## **Safety Evaluation Report**

# **Development of a Novel Efficient Solid-Oxide Hybrid for Co-generation of Hydrogen and Electricity Using Nearby Resources for Local Applications**

**Materials and Systems Research, Inc. (MSRI)  
Salt Lake City, UT  
February 17, 2009**

Figure 1. The MSRI shed

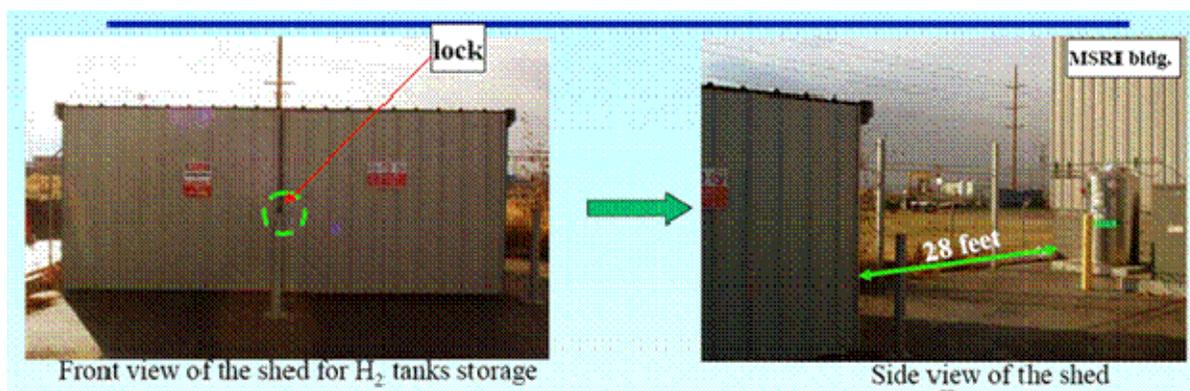
Members of the Hydrogen Safety Panel performed a telephone interview with MSRI on December 4, 2008. During the telecom, MSRI reported that the hydrogen it uses for this project was being stored in a shed (Figure 1) near its experimental facility and in quite close proximity to the fence-line on the adjoining property. The shed was reported to contain 36 cylinders of hydrogen in two 18-cylinder "pods." Both pods were connected to a common manifold within the shed, where a regulator reduced the hydrogen pressure to 30 psi into a stainless steel pipe to the building. The telephone interview report recommended that **"a site visit be made to MSRI to allow us to better understand the potential issues with the hydrogen shed. A break in the common manifold could cause a release of 36 tanks of hydrogen at once. There is the potential that this could result in a hazardous situation – possibly a fire or even an explosion."**

**Figure 2.** The inside of the shed, showing the pods, manifold, and hydrogen flow channels in the ceiling.

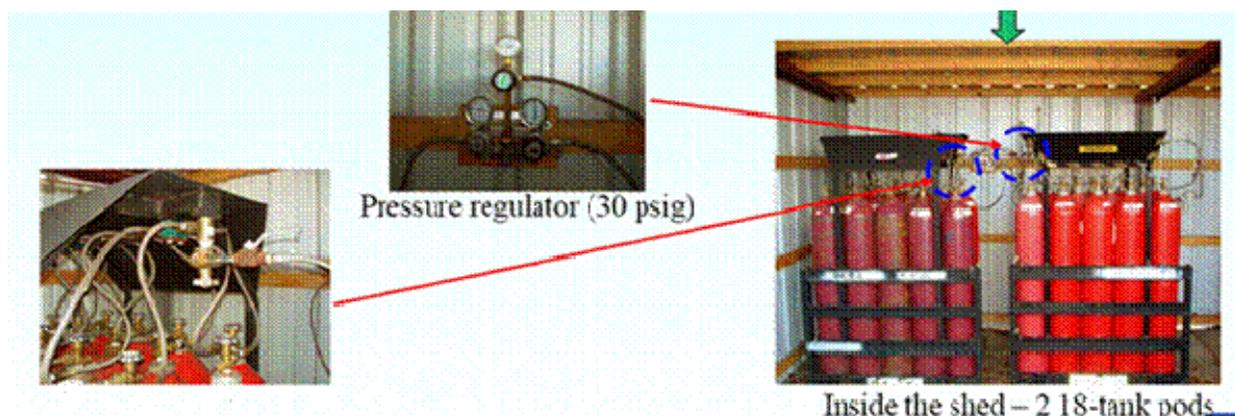
Sloping upward back to front, the shed has an internal volume of about 1700 cubic feet (cu ft) and is enclosed by metal walls, a roof, and doors. There are small openings between the wall and gaps around the doors. In addition, there are many flow channels in the shed ceiling (Figure 2) that, along with the sloping roof and the many gaps, allow adequate paths and locations for venting minor hydrogen leaks. These would be far from adequate, however, as a means to disperse a large, rapid release of hydrogen into an otherwise enclosed space.

Should a large hydrogen release occur, the shed's solid walls increase the risk in three ways. First, the walls will confine a hydrogen release and increase the size and duration of the flammable gas cloud. Second, should an ignition of the flammable cloud occur, confining walls could allow an explosion to develop with potentially dangerous pressures and an expanding fireball. Third, the walls and roof could become projectiles and increase the potential for personnel injury and damage to nearby equipment and facilities.

- **Recommendation 1.** The safety review team recommends that MSRI consider methods to mitigate a potentially dangerous sudden release of hydrogen from a cylinder or a pod of cylinders into the storage shed. One potential solution would be to retain the roof but replace the shed's solid walls with a chain-link fence enclosure.

MSRI: "MSRI plans to replace up to half of the shed's walls and door with chain-link fence material. The bottom half of the walls will be retained to reduce the accumulation of foreign matter."

Safety Review Team: The safety review team recognizes the limitations under which MSRI is operating. The removal of the top halves of the four walls of the shed will likely provide significant improvement to the virtually enclosed storage shed. If there is a hydrogen leak in the storage area, there is a reduced probability that the released hydrogen will remain confined by the half-walls for a sufficient amount of time for an explosion to occur. However, the level of confinement, over-pressurization, and potential damage would likely be higher if there were only chain-link fence walls.
